Florida Department of Transportation

DCE MEMORANDUM NO. 25-14
(FHWA Approved: 12/10/2014)

SUBJECT: STRUCTURAL GROUT PADS – MAST ARMS AND CANTILEVER SIGN STRUCTURES

LAST REVISION 07/01/14	REVISION	DESCRIPTION:	 2015 DESIGN STANDARDS	CANTILEVER SIGN STRUCTURE	INDEX NO. 11310	SHEET NO. 1 of 5
---------------------------	----------	--------------	--	----------------------------------	---------------------------	----------------------------

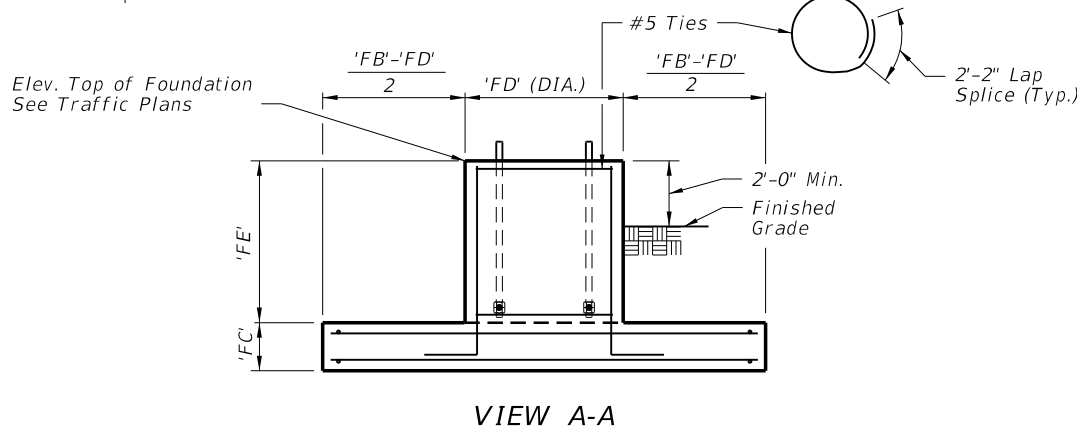
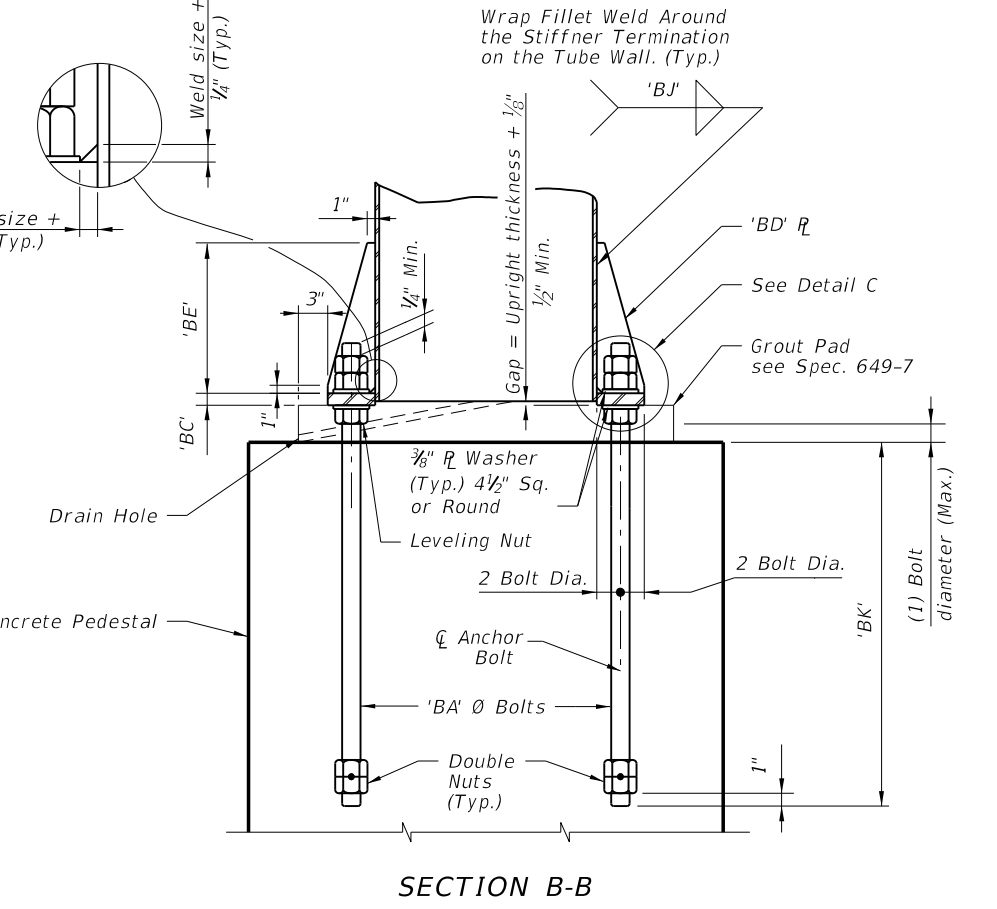
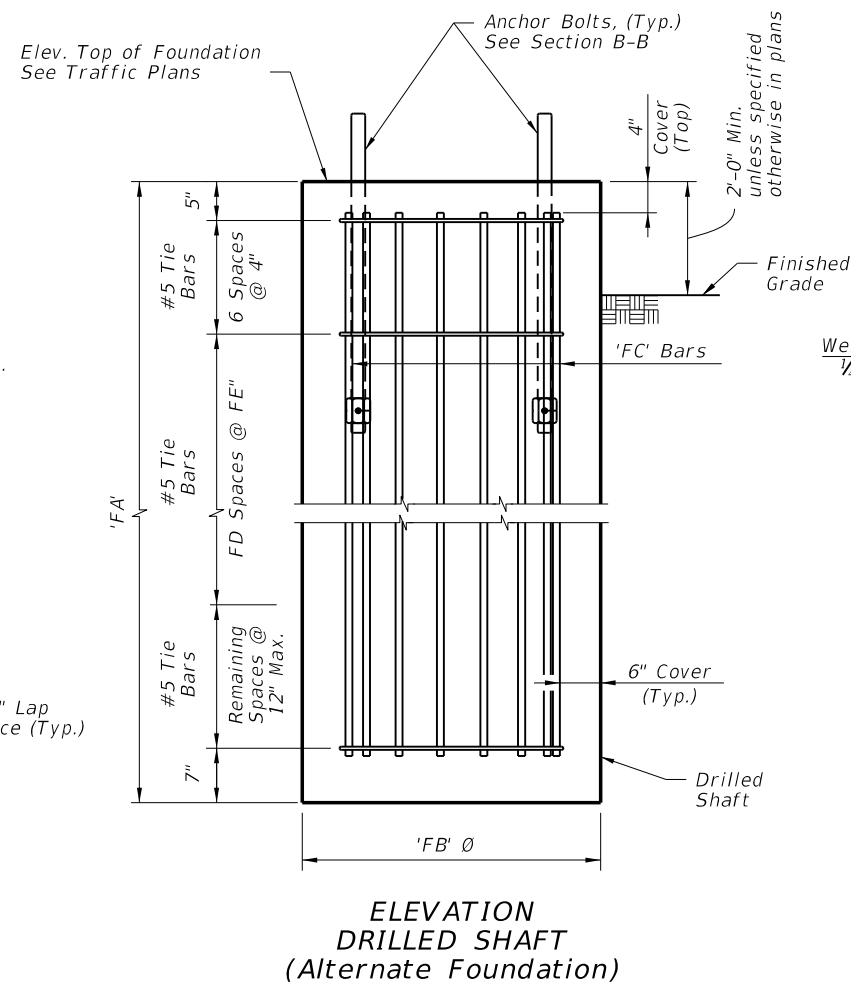
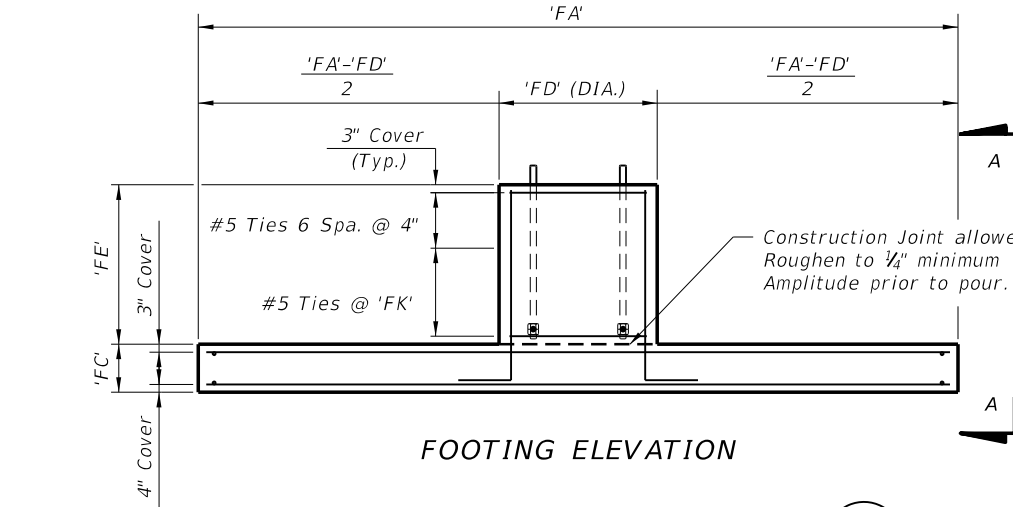
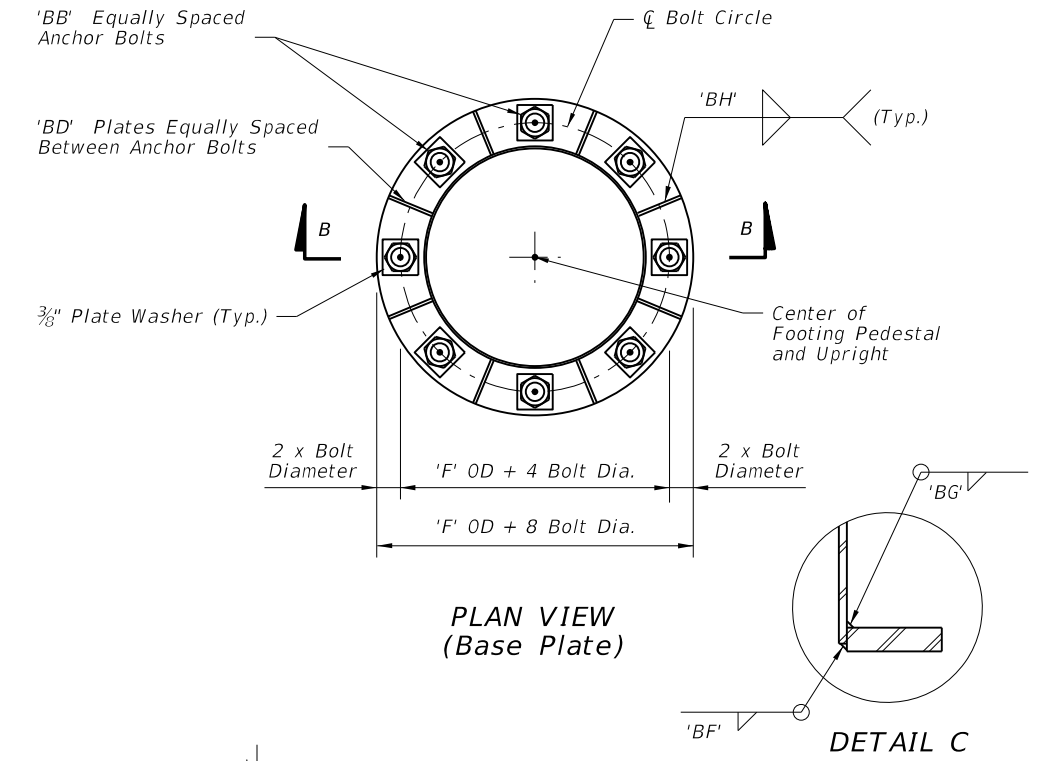
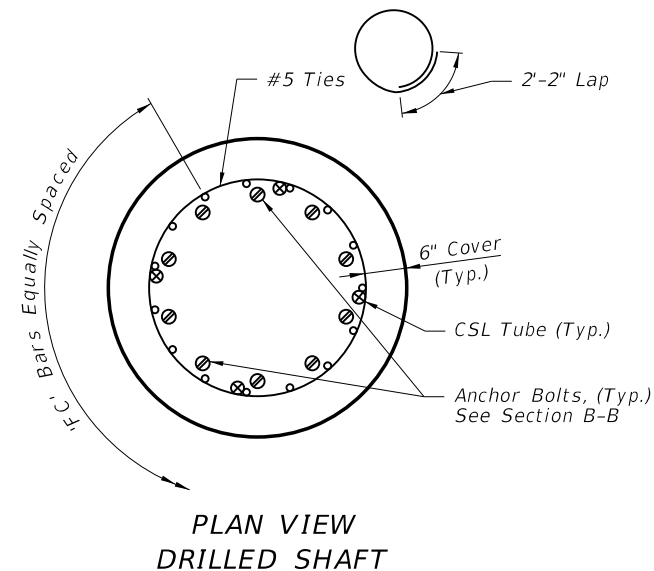
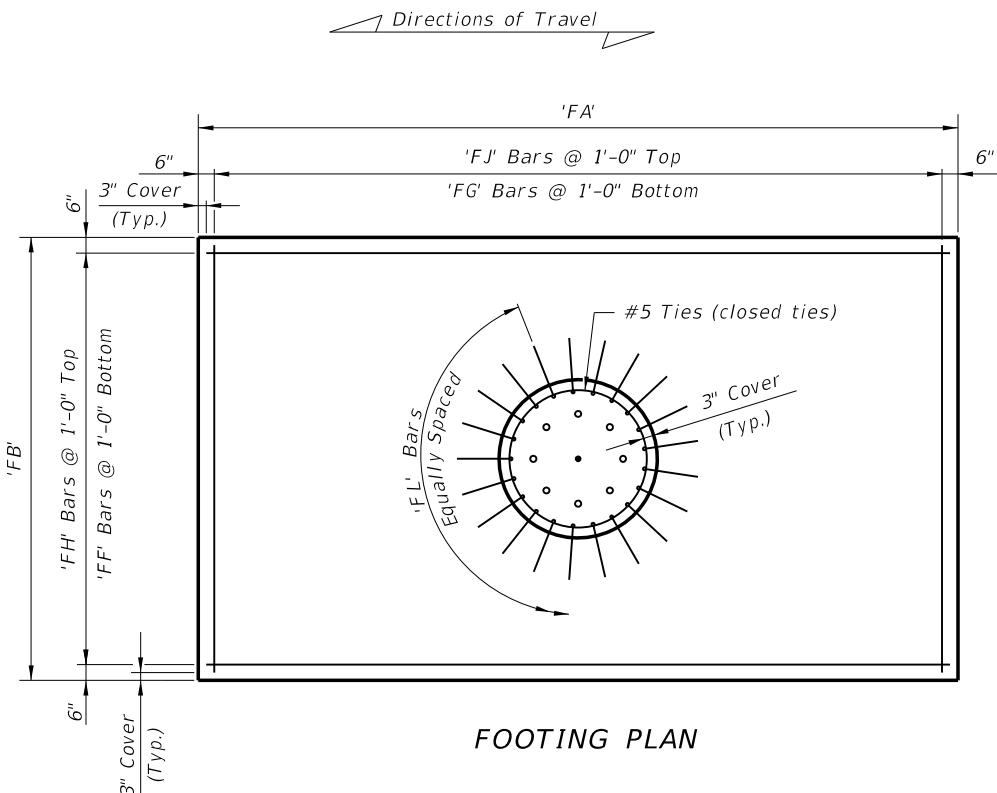
Currently, mast arm structures and cantilever overhead sign structures have a vermin screen installed between the drilled shaft and the base plate. Effective with January 2015 lettings, these structures will have a structural grout pad installed between the drilled shaft and the base plate.

Specification Subarticles 649-5, 649-7, and 700-2.2.3 and Design Standards Indexes 11310 - Cantilever Sign Structure and 17745 - Mast Arm Assemblies have been modified to depict construction of the structural grout pad for affected structures.

700-2.2.3 Installation: Install nuts on anchor bolts in accordance with Section 649 with the following exception. For cantilever overhead sign structures, after placement of the upright and prior to installation of the truss, adjust the leveling nuts beneath the base plate to achieve the back rake shown on the Camber Diagram. If the top surface of the base plate has a slope that exceeds 1:40, use beveled washers under the top nuts. For span overhead sign structures, install a screen around the base plate in accordance with 649-6. For cantilever overhead sign structures, install a structural grout pad in accordance with 649-7.
